CORPORATE LAKES 3RD

Re: S/D 98-49-- One-Step Final Plat of CORPORATE LAKES 3RD ADDITION

Re: S/D 98-49 -- Final Plat of CORPORATE LAKES 3RD ADDITION

CASE NUMBER: S/D 98-49 - CORPORATE LAKES 3RD ADDITION

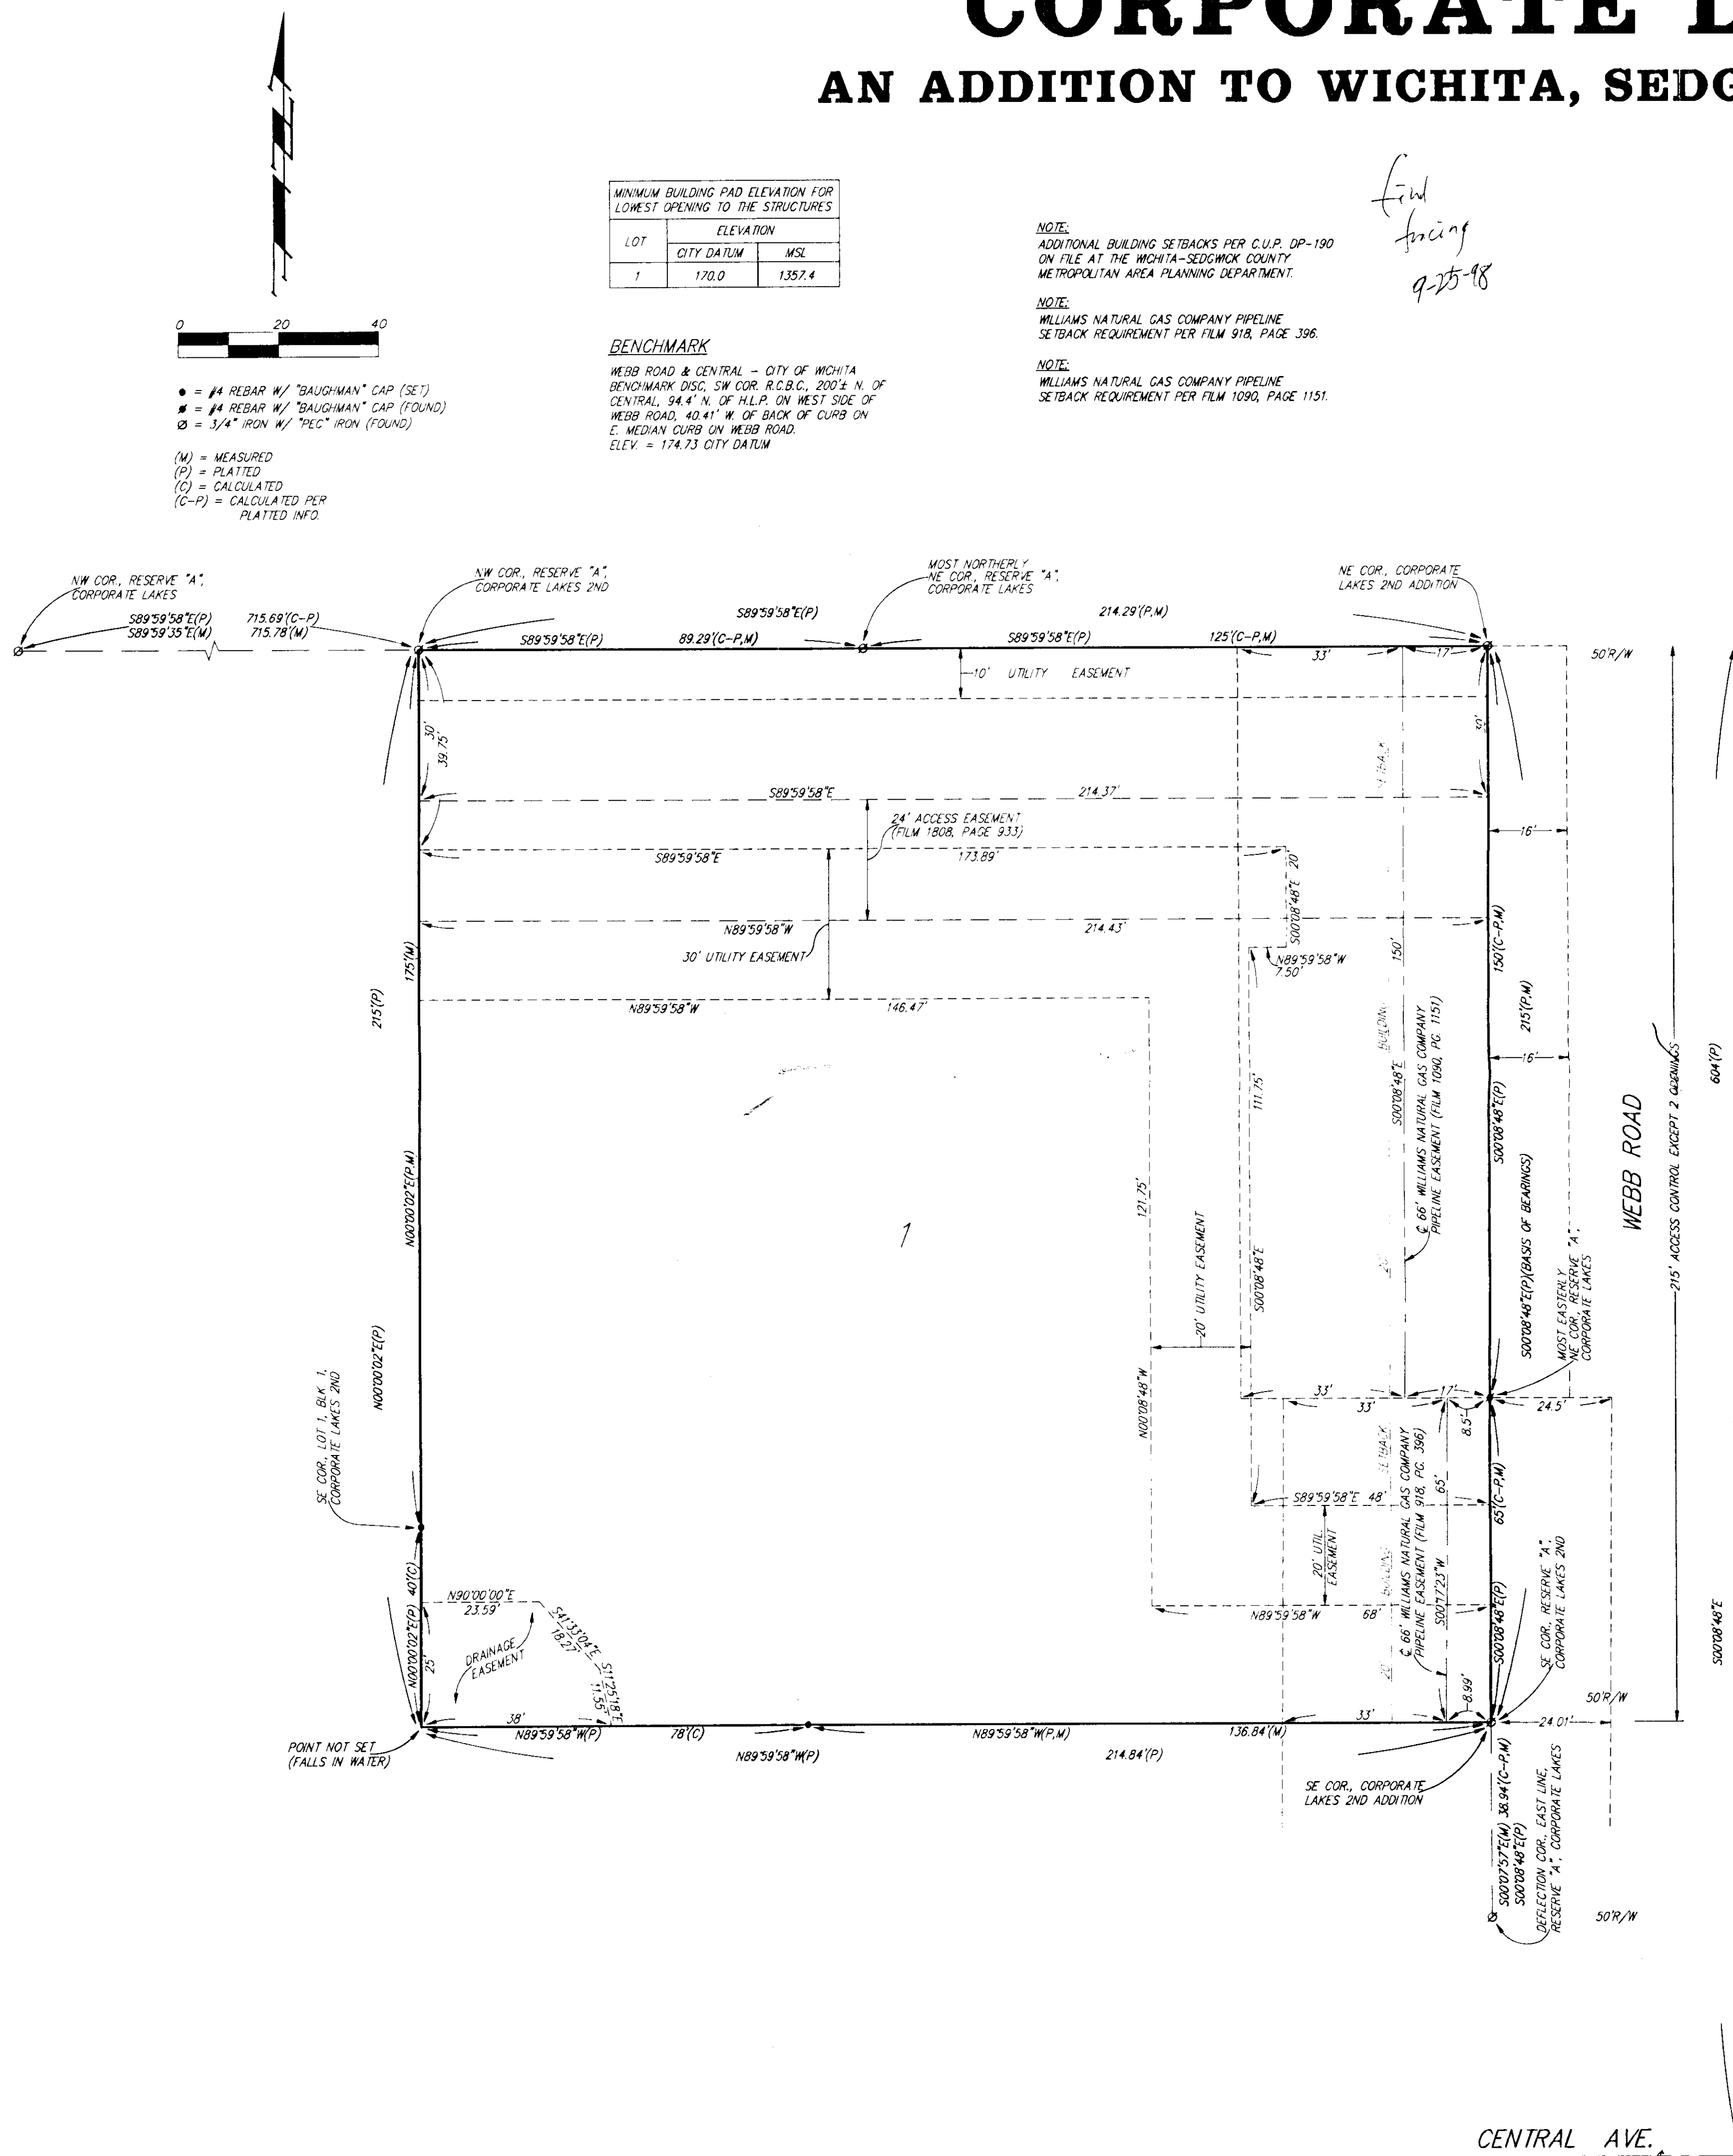
- C. City Engineering needs to comment on the status of the applicant's drainage plan.
- D. Traffic Engineering needs to comment on the proposed access controls. The plat depicts two openings along Webb Road. The associated CUP - which denotes one access opening along this portion of the site - will require an adjustment to permit two openings for this site along Webb Road. On the final plat tracing, the platlor's text shall reference access control. Traffic Engineering has approved the two openings subject to reaching an agreement with the Applicant regarding Item L before approval by the MAPC.

- E. ✓ The proposed access easement will need to be established by separate instrument.
- F. ✓ The applicant shall submit a copy of the instrument which establishes the pipeline easements on the property, which verifies that the easements shown are sufficient and that utilities may be located adjacent to and within the easements.

- G. ✓ The applicant's agent shall determine any setback requirements for the pipelines by researching the text of the pipeline agreements. If a setback from the pipeline easements is

provided for in the pipeline easement agreements, it shall be indicated on the face of the plat.

- I. The final plat tracing shall reference a tie point to a section corner along with distance to this plat.
- J. On the final plat tracing, the MAPC Chairman should be revised to read, "Richard E. Lopez".

- K. Building setback lines were established with the CUP and the previous plat. This plat proposes to reduce the building line along Webb Road from 60 feet to 20 feet. If this reduction is granted with the approval of this plat, an adjustment to the CUP will be approved.

- L. Traffic Engineering needs to comment on the need for any improvements to Webb Road. **A northbound left-turn lane shall be constructed along Webb Road.**

- M. The name of the Addition referenced in the surveyors signature block needs to read, "Corporate Lakes 3rd".
- N. The applicant shall install or guarantee the installation of all utilities and facilities which are applicable and described in Article 8 of the MAPC Subdivision Regulations. (Water service and fire hydrants required by Article 8 for fire protection shall be as per the direction and approval of the Chief of the Fire Department.)
